Unified Indoor Tactical Recon Robotic System

RELEASE NOTE

FIRMWARE GCS MkII v3.3.2

July 2024

/ Region Selection

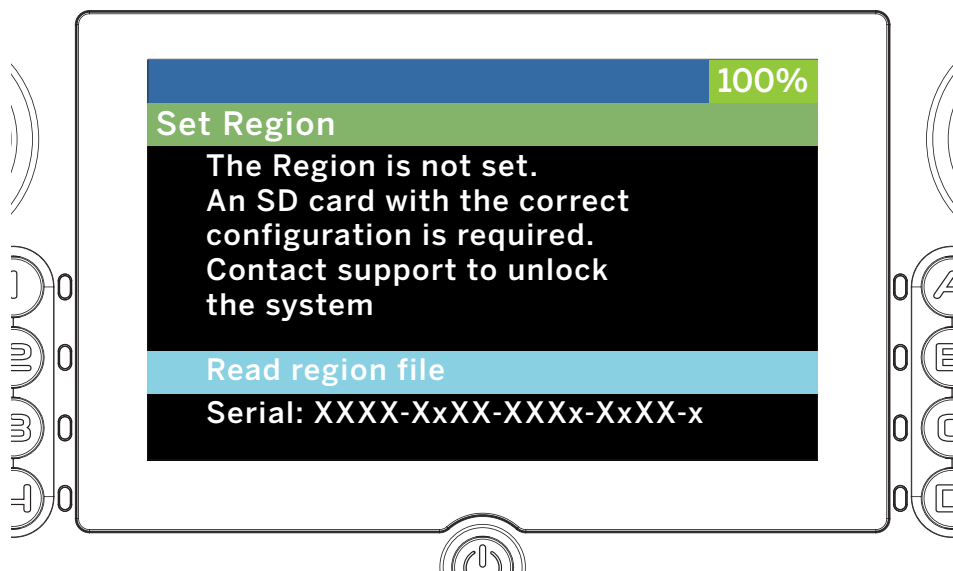
The region selection process on the GCS MkII has undergone significant restructuring to ensure compliance with regulatory requirements, particularly aligning with FCC waivers in the United States of America. Users can no longer set the region by directly choosing FCC or CE options. Instead, access to specific regions now requires users to upload a region-specific code file via a Micro-SD card onto the GCS MkII.

There are 4 regions that can be configured now:

- FCC compliant
- FCC open
- CE compliant
- CE open

The open variants remain identical to the previous CE and FCC configurations. Users can continue to toggle between open and compliant settings as before. Existing customers upgrading will automatically transition to the open version corresponding to their region, ensuring zero disruption to their current usage. New customers will configure their region using the file provided by AXON.

The file required is named «gcs.cfg» and will be provided by your AXON representative or local distributor.

To unlock to the GCS MKII, upload the file into a Micro-SD card formatted with FAT32 (compatible with cards up to 32GB). Insert the Micro-SD card into the designated slot on the GCS MkII and proceed to select the option «Read region file».
